MILITARY SPECIFICATION

BAND, ROTATING, NYLON GLASS-FILLED FOR PROJECTILE, 105MM, M737, TPDS-T

This Amendment forms a part of Military Specification MIL-B-63454 (AR), dated 7 September 1982, and is approved for use within the US Army Armament, Munitions and Chemical Command and is available for use by all Departments and Agencies of the Department of Defense.

FIGURE 1. NYLON ROTATING BAND TEST SPECIMENS

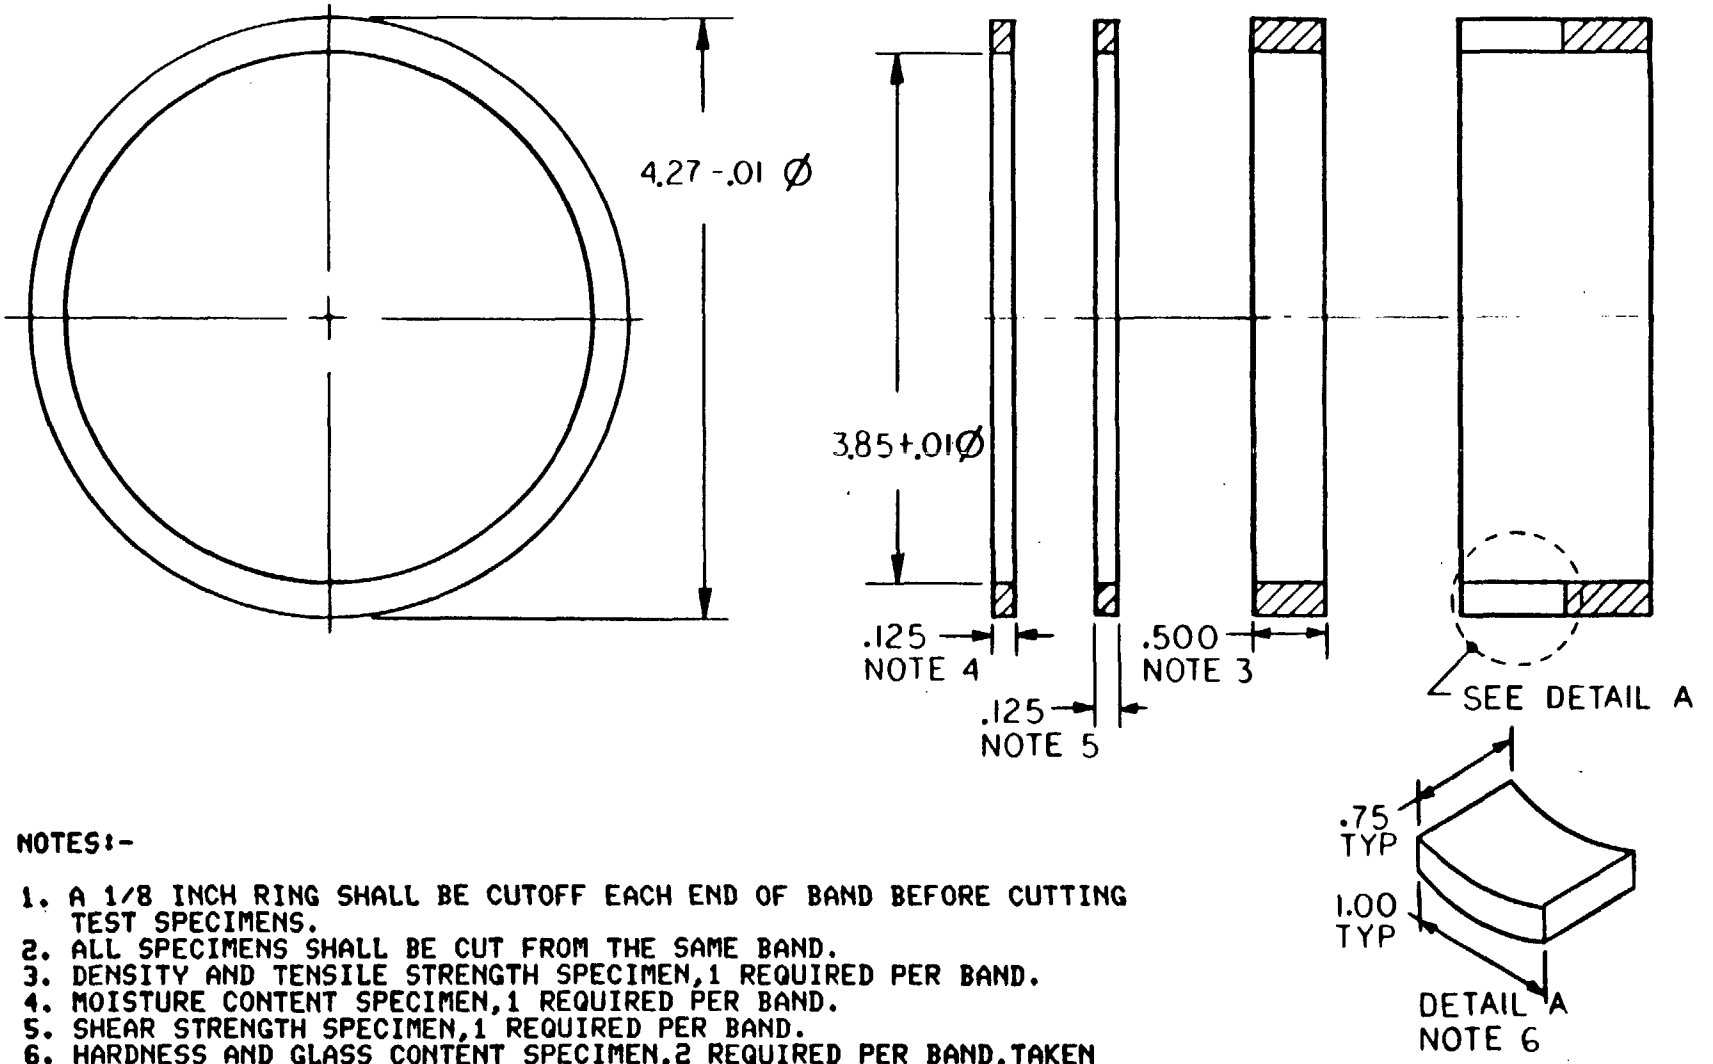
Figure 1, delete in its entirety and substitute Figure 1, (included).

FIGURE 3 DISC AND BASE ASSEMBLY

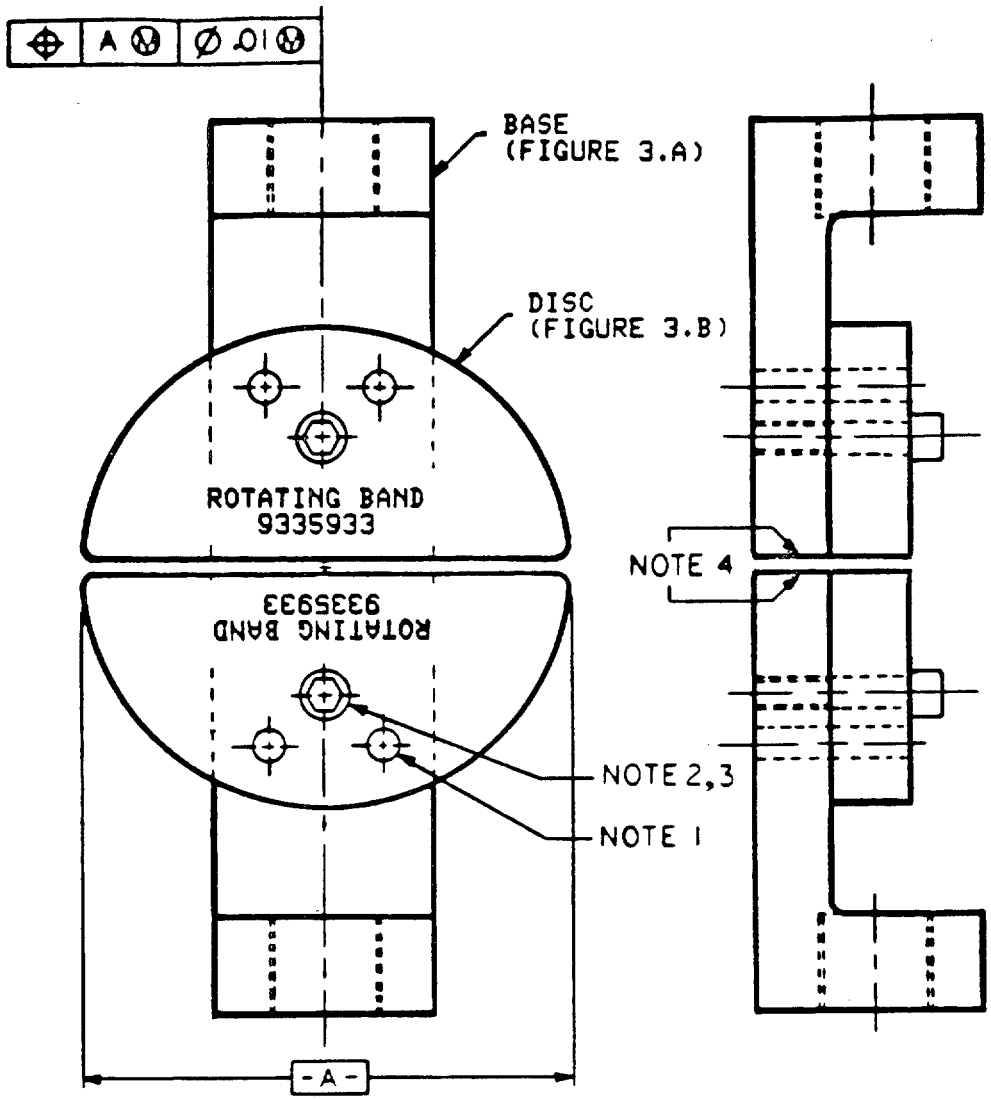
Para b, delete in its entirety and substitute: "b. The test fixture shall conform to Figure 3 or its approved equivalent. (Ref. MIL-A-48078)."

Figure 3, delete in its entirety and substitute Figures 3, 3A and 3B (included).
